Application number: 2026/62/91628/W
Applicant Jones Homes (Yorkshire) Ltd
Objection - recommend refusal of the planning application 2026/62/91628/W

Reply to initial planning application: 2026/62/91628/W

Site address: land off, Boshaw View, Hade Edge, Holmfirth, HD9 2TZ

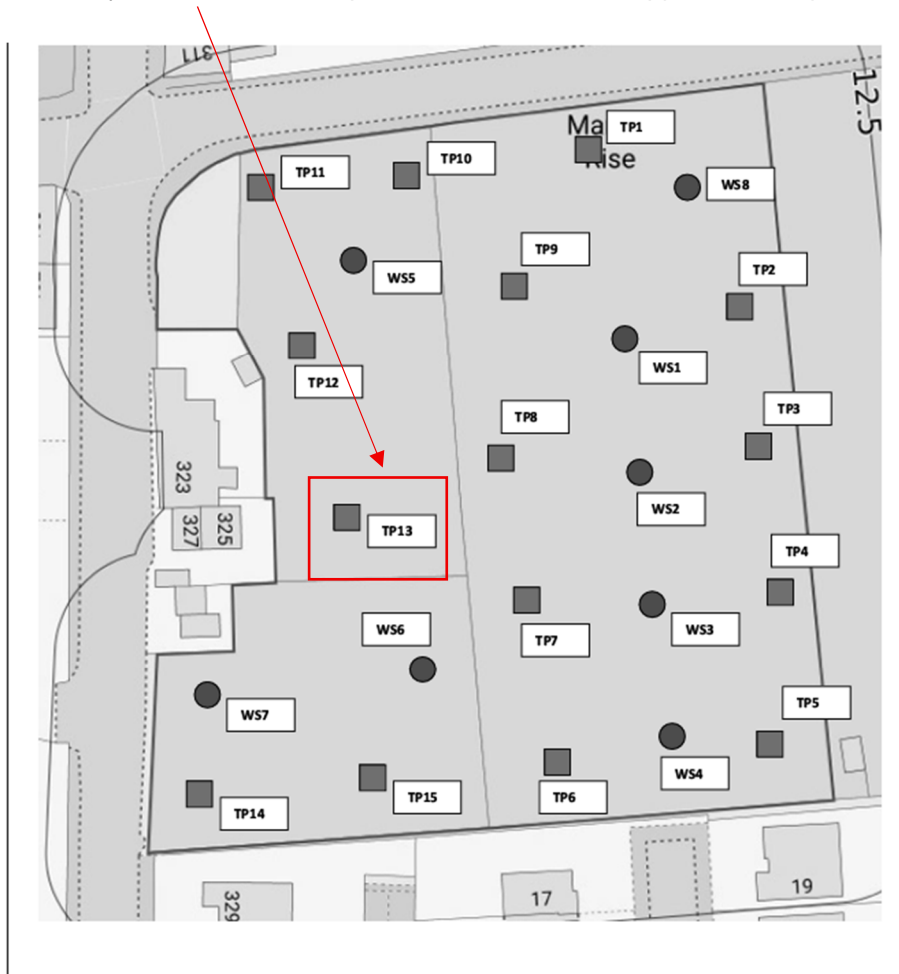
Trees – Concerns the dwellings shown on the proposed scheme are too close to the existing TPO'd trees.

The amendments are not far enough away to avoid contact with roots and potentially the branches of the trees. The proposed layout should be amended and re-submitted to address these concerns.

The submitted layout had been amended to position the dwellings further away from the trees. An AIA has also been submitted with the application confirming there will be no adverse impact on the trees from the proposals.
